Subject: Response to U.S. EPR Design Certification Application RAI No. 354, FSAR Ch. 3

# Request for Additional Information No. 354(4106,4107,4220), Revision 0

U. S. EPR Standard Design Certification AREVA NP Inc. Docket No. 52-020

**Application Section: FSAR Ch 3**

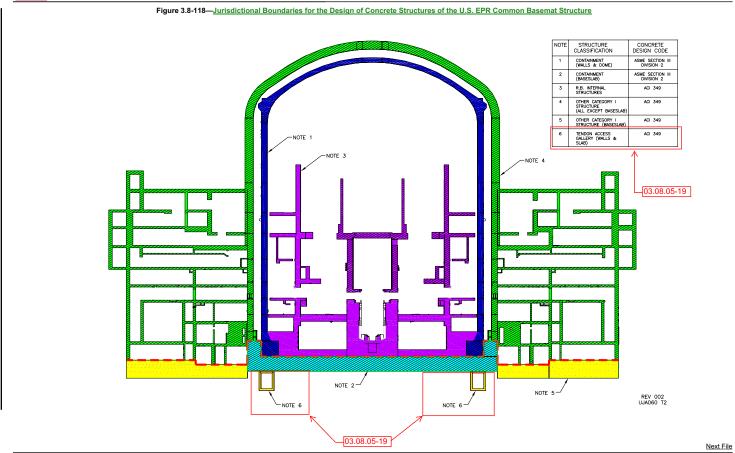
The RAI responses indicates that the connection of the tendon gallery to the NI Common Basemat Structure allows for differential movement between the two concrete structures without immediate transfer of load. The staff finds that this is no longer valid in light of the response to RAI 3.8.5-8, which states that: (a) a new SSI analysis of the NI Common Basemat Structure has been performed using fully embedded conditions to address sliding and overturning issues; and (b) the new analysis models the tendon gallery as a shear key (i.e. structurally connected to the NI Common Basemat Structure). Therefore, clarify and update the relevant sections of the FSAR so that they are consistent with the aforementioned new analysis assumptions. Since the tendon gallery is now considered to be structurally connected to the NI Common Basemat Structure, confirm that it is categorized as a Seismic Category I structure and provide a description of the tendon gallery configuration, analysis approach, and design comparable to the other Seismic Category I structures. In addition, include a summary of this information in the relevant sections of the FSAR.

In addition, since the RAI response states that groundwater infiltration into the tendon gallery is considered a maintenance issue to be minimized by the use of waterstops and water proofing below grade, then confirm whether a maintenance program in accordance with 10 CFR 50.65 will be implemented for the tendon gallery. The need for such a program is particularly important since the tendon gallery should now be classified as a Seismic Category I structure. Furthermore, the structural integrity of the RCB relies on the anchorage of the post-tensioning system, which could be subject to corrosion from moisture effects resulting from groundwater seepage into the tendon gallery.

The tendon access gallery will be designed and constructed monolithically with the Nuclear Island (NI) Common Basemat Structure. The tendon gallery is included in the embedded finite element model (FEM) of the NI Common Basemat Structure. U.S. EPR FSAR Tier 2, Section 3.8.5.1.1 and Figure 3.8-118 will be revised to clarify that the tendon access gallery is used as a structural element for the transfer of horizontal shear forces from the NI Common Basemat Structure to the soil.

U.S. EPR FSAR Tier 2, Section 3.8.5.1.1 and Figure 3.8-118 will be revised as described in the response and indicated on the enclosed markup.

03.08.05-19
